**ALAMEDA COUNTY COMMUNITY DEVELOPMENT AGENCY
PLANNING DEPARTMENT**

STAFF REPORT

APPLICATION TYPE & NUMBER: Preliminary Rezoning, PLN2014-00173

PROPOSAL: To allow a General Plan Amendment (open space to residential), a rezoning and a subdivision (TR-8218) of 1 site from a PD (Planned Development) District allowing Neighborhood Commercial uses to a PD District allowing 8 single family dwellings.

SHEET NO. **C5.0**

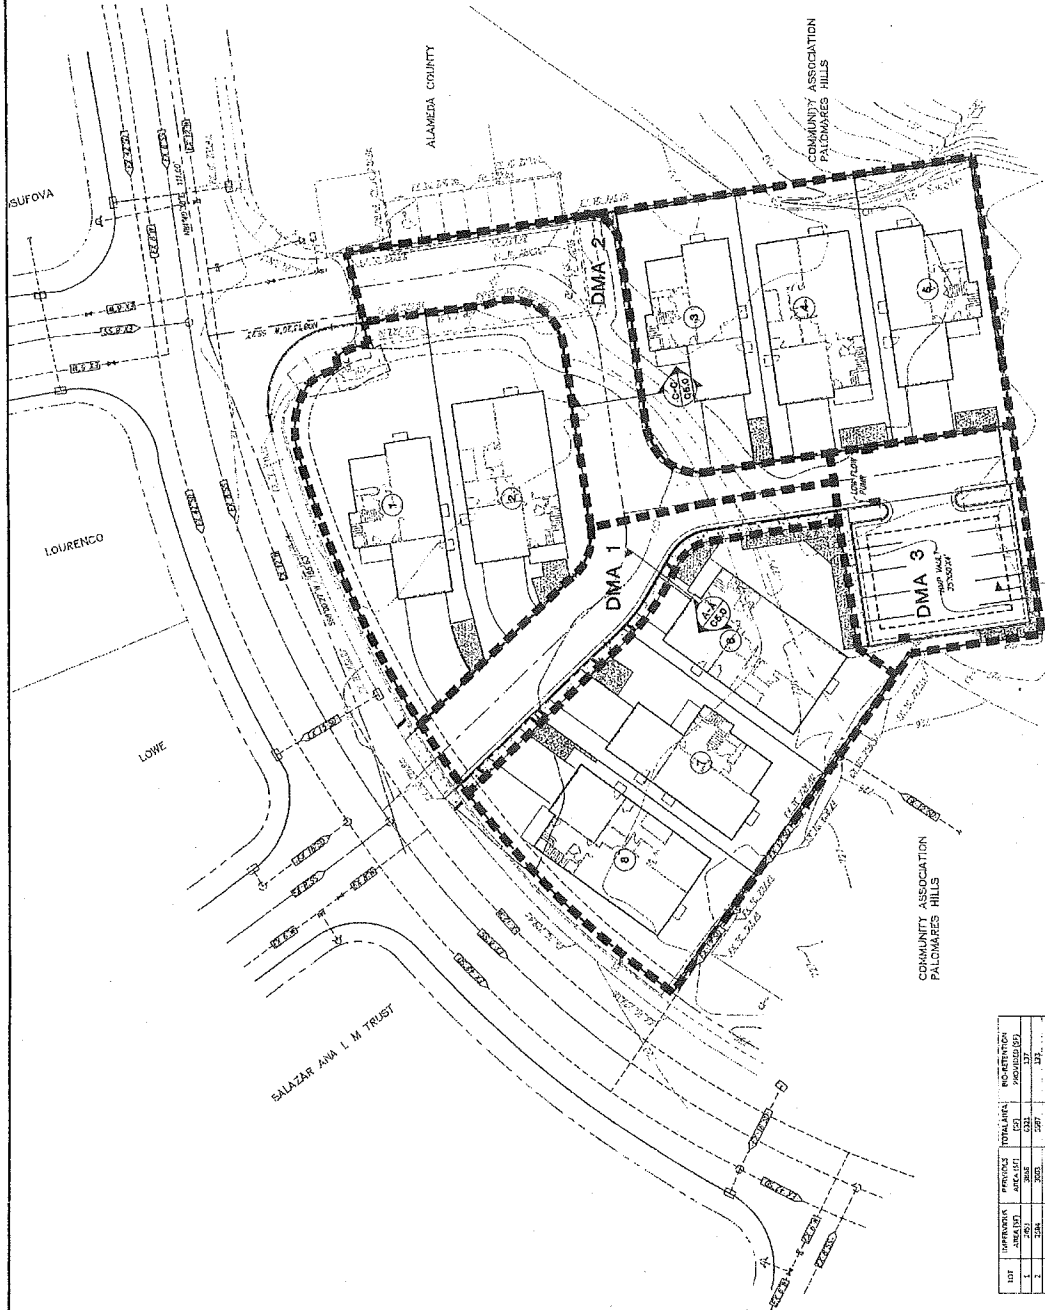
I reviewed the plan sheet C5.0 again. Instead of including a sizing chart have Mr. Azar modify the tables at the lower left of the page to include a column for the treatment area required for each of the drainage areas. Additionally, please also have each of the treatment areas named/labeled. It is not intuitive as to which treatment unit corresponds to each of the DMAs.

How will the water from the driveways be captured and routed into each lot's BRA? It may be more feasible to include the driveway areas into the DMAs instead of lot treatments.

20. The applicant should complete the Stormwater Requirements Checklist and any additional infeasibility forms that may be required.
21. The cross-sections on page C5.0 differ from those shown in the Technical Guidance. The developer should revise their drawings. If the Bio-Retention Areas are allowed through the infeasibility process then, the plan view of these units should be modified to show the slope and bottom of the treatment area. A sizing chart should also be included onto the sheet.
